## SUMMARY OF CONCERNS IN RELATION TO THE PROPOSED NORTHCONNEX TUNNEL

**This is an objection to many aspects of the proposed NorthConnex tunnel.**

Figure 5-17 Motorway operations complex

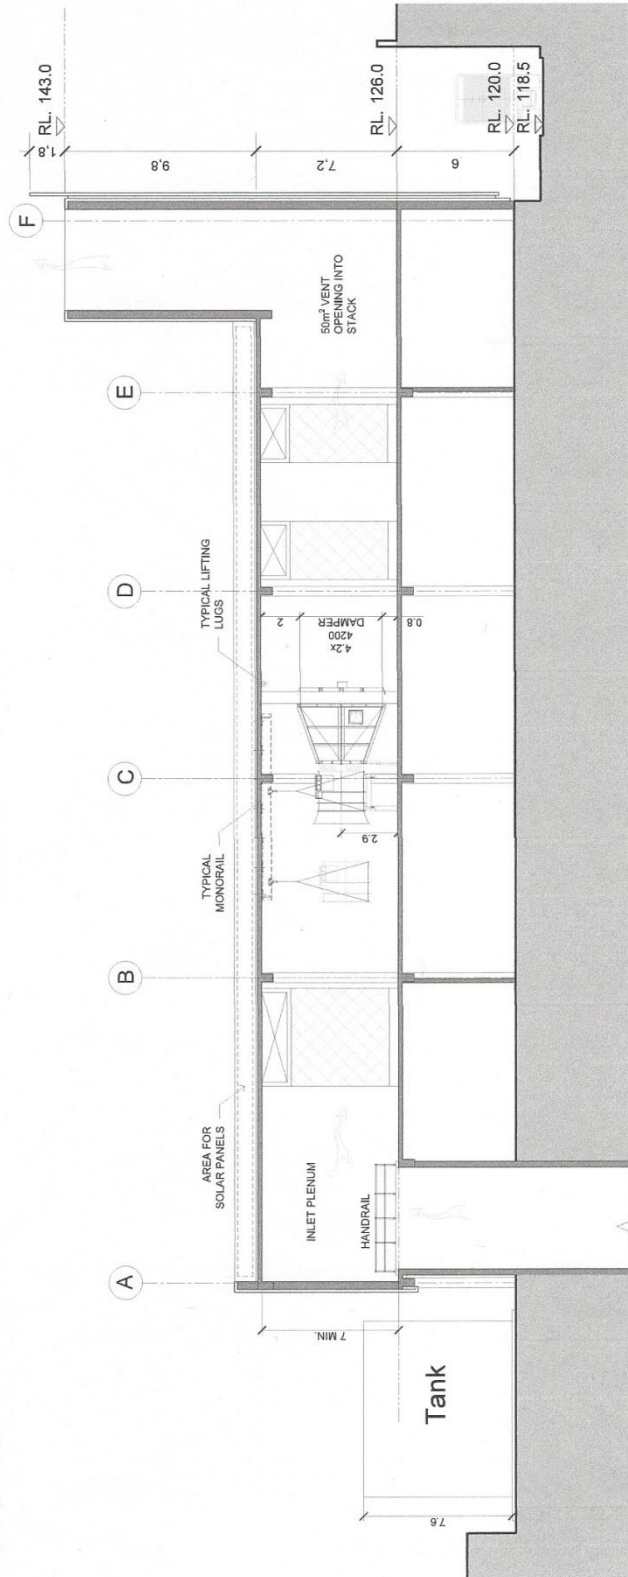
EIS Page 111, *Figure 5-17 Motorway operations complex*

*Page 8 below* there is no indication of how the ventilation facility will be connected to either the northbound or southbound tunnel, nor is there any indication of how the southbound exit portal onto Pennant Hills Road or the south-west exit portal onto the M2 will be connected.

M1-M2-5000-DR-UD-0550  
NORTHERN VENTILATION FACILITY - CROSS SECTIONS

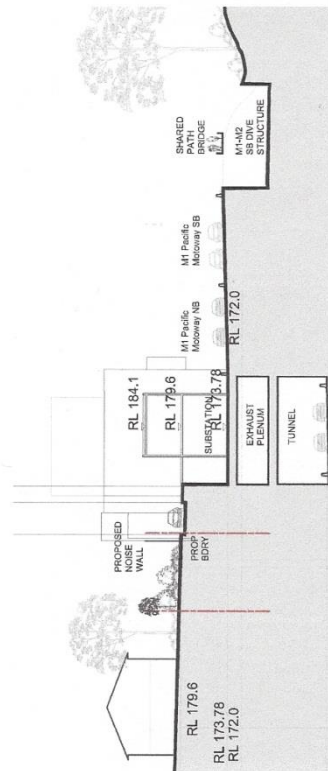
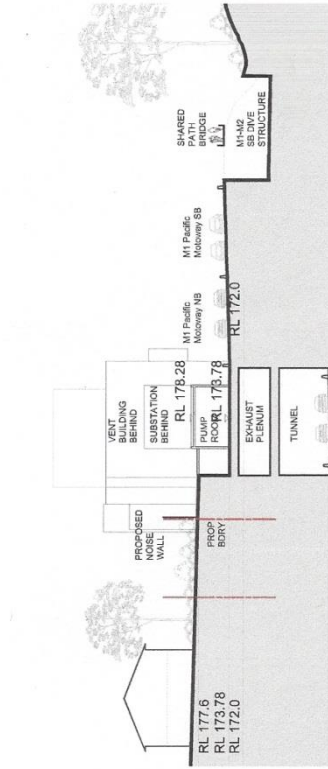
EIS page 135 *Page 11 below* there is a very explicit diagram showing the *Northern Ventilation Facility – cross section*.

EIS page 134 *Page 12 below* there is a very explicit diagram showing the *Northern Ventilation Facility – long section*.

Why are there no comparable diagrams for the Southern Interchange and the Southern Ventilation facility?

M1-M2-5000-DR-UD-0725  
NORTHERN VENTILATION FACILITY - LANDSCAPE CONCEPT SECTION

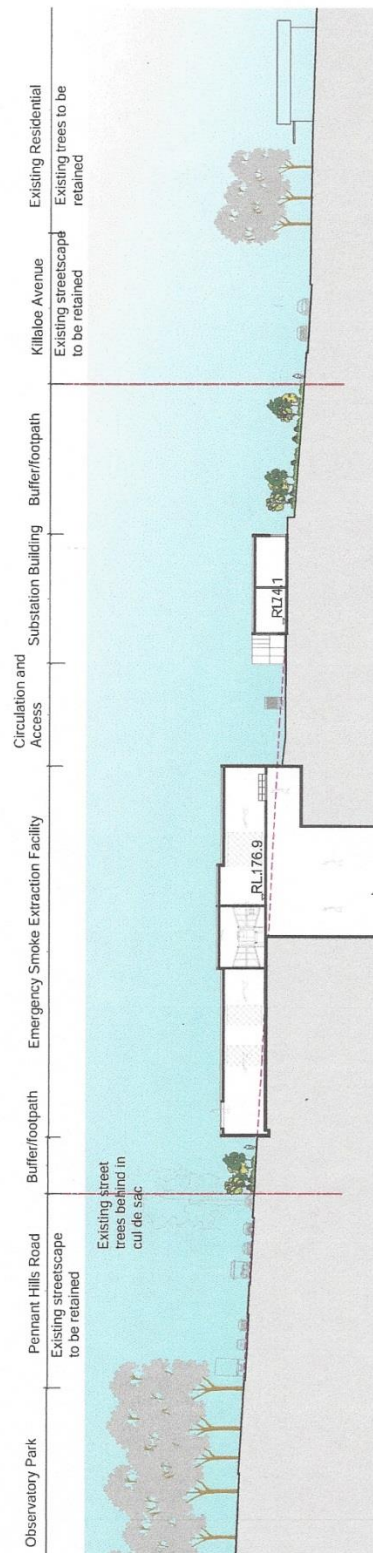
6. *EIS Volume 4, Technical working papers Urban Design, 8.0 Landscape Design*  
EIS Page 176 is the diagram "Motorway Operations Complex – Southern Ventilation Facility – Site 1-1". *Page 13 below* The diagram does not show any connection to either the northbound or southbound tunnel. In the same Landscape Design section, EIS Page 182 is the diagram "Wilson Road Tunnel Support Facility –Section" *Page 14 below* which clearly shows the connection to the tunnels. In the same Landscape Design section, EIS Page 189 is the diagram "Northern Ventilation Facility – Landscape Concept Section". *Page 15 below* This also clearly shows the connection to the tunnels.
